# United States Patent and Trademark Office

APPLICATION NO.	FILING DATE	FIRST NAMED INVENTOR	ATTORNEY DOCKET NO.	CONFIRMATION NO.
10/797,463	03/10/2004	Kyoung-Hwan Yeo	5649-1238	4432
20792 7590 05/29/2007 MYERS BIGEL SIBLEY & SAJOVEC PO BOX 37428			EXAMINER	
PO BOX 37428	3		STARK, JARRETT J	
RALEIGH, NC 27627			ART UNIT	PAPER NUMBER
			2823	
			MAIL DATE	DELIVERY MODE
			05/29/2007	PAPER

#### **DETAILED ACTION**

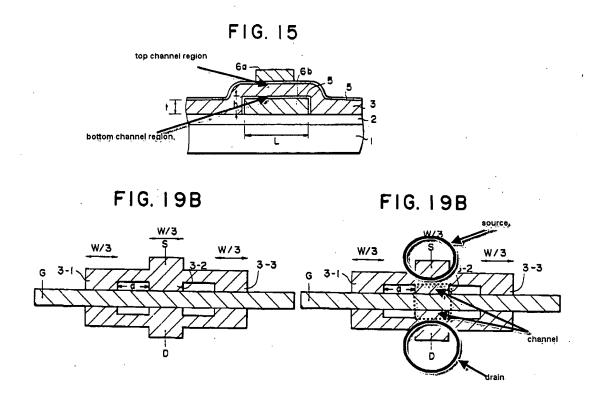
First, in regards to the two horizontal channel regions the Maegawa's Abstrat states "the control electrode forms a channel in each of two opposed surfaces of the channel member." Thus, two horizontal channel regions formed in spaced apart patterns. One on the top surface and one on the bottom surface. See marked-up figure 15 below. It is also noted Figure 30 also depicts numerous spaced apart horizontal channels formed from multiple epitaxial layers stacked vertically.

In regards to the source and drain regions are formed in other patterns adjacent to sides of the spaced apart patterns. This is shown in Figure 19B below which has also been marked-up for clarity. Figure 19B will also correspond to the lotions of the source/drains formed in the multiple layer and multiple channel device depicted in figure 20.

# FIG. 15

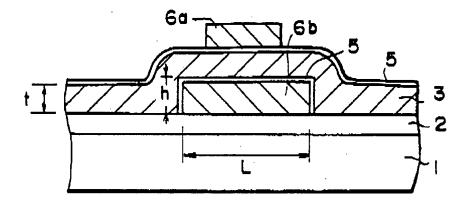
Regarding claims 12 and 30, Maegawa discloses a method of forming a unit cell of a metal oxide semiconductor (MOS) transistor, comprising: forming a MOS transistor (Fig 15) on an integrated circuit substrate (Fig 15 –[1]), the MOS transistor having a source region, a drain region and a gate, the gate being between the source region and the drain region (Fig 15 & Col. 6 lines 53-57); and

forming a horizontal channel between the source and drain regions, the horizontal channel including at least two horizontal channel regions formed in spaced apart patterns, wherein the source and drain regions are formed in other patterns adjacent to sides of the spaced apart patterns (Abstract & Fig 15 – layer 3 forms the channel member/region, the channel region has two horizontal channels the one at the top surface adjacent the top gate electrode and a second adjacent the bottom gate electrode – Also see above response to arguments).

Regarding claim 20, Maegawa in view of Nakajima discloses the method of claim 19, further comprising: forming a second insulation pattern (Fig. 15 – [5]) on the horizontal channel and the vertical source and drain regions (Fig. 15 – [3] – source and drain regions left and right of gate 6a), wherein the second insulation pattern defines a gate opening on the horizontal channel (Fig. 15 – circled by Examiner for clarity), wherein the gate pattern is provided in the gate opening and

Regarding claim 22, <u>Maegawa</u> in view of <u>Nakajima</u> discloses the method of claim 21, wherein an upper surface of the first insulation pattern is higher relative to a lower surface of the gate pattern. (<u>Maegawa</u>, Fig. 15 first insulating layer [5] is above lower gate pattern [6b])

FIG. 30

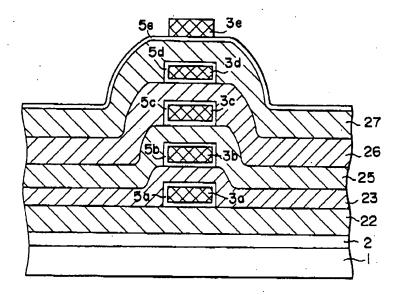
Regarding claim 17, Maegawa discloses the method of claim 16, further comprising: forming a gate pattern (Fig 30-[26]) on the horizontal channel (Fig 30-[3c]) and between the at least two spaced apart horizontal channel regions (Fig 30-[3c and

3d]); and forming a gate insulation layer (Fig 30-[5c and 5d])between the gate pattern and the at least two spaced apart horizontal channel regions.

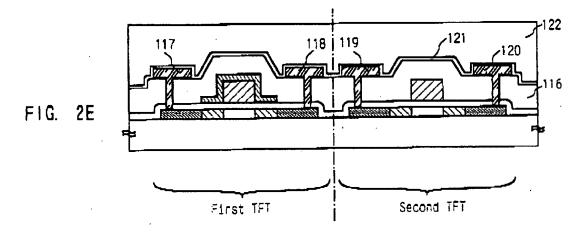
Maegawa does not explicitly disclose wherein the source and drain electrodes extend through the second insulation pattern and are connected to the vertical source drain regions. It is however notoriously well known extend the source and drain

electrodes through the insulation pattern to make electrical contact with the source and drain electrodes. An example of this is shown by <a href="Nakajima">Nakajima</a> in Figure 2E below. The figure shows a commonly used method of connecting source and drain electrodes to the source and drain trough an insulating layer.

It would have been within the scope of one of ordinary skill in the art at the time of the invention to combine the teachings of <a href="Maegawa">Maegawa</a> and <a href="Maegawa">Nakajima</a> to enable the source/drain electrode formation step of <a href="Maegawa">Maegawa</a> to be performed according to the teachings of <a href="Nakajima">Nakajima</a> because one of ordinary skill in art at the time of the invention would have been motivated to look to alternative suitable methods of performing the disclosed source/drain electrode formation step of <a href="Maegawa">Maegawa</a> and art recognized suitability for an intended purpose has been recognized to be motivation to combine.

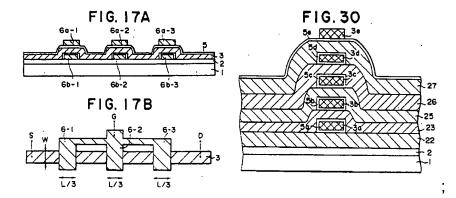
forming a trench region on an integrated circuit substrate to define an active region (Maegawa, Fig. 1A);

forming a stacked structure including at least one set of first epitaxial patterns and second epitaxial patterns on the active region (Maegawa, Fig. 30);

forming a first insulation pattern on a floor of the trench (<u>Maegawa</u>, Fig. 1B);; growing a third epitaxial layer on sidewalls of at least one set of first and second epitaxial patterns(<u>Maegawa</u>, Fig. 1A);
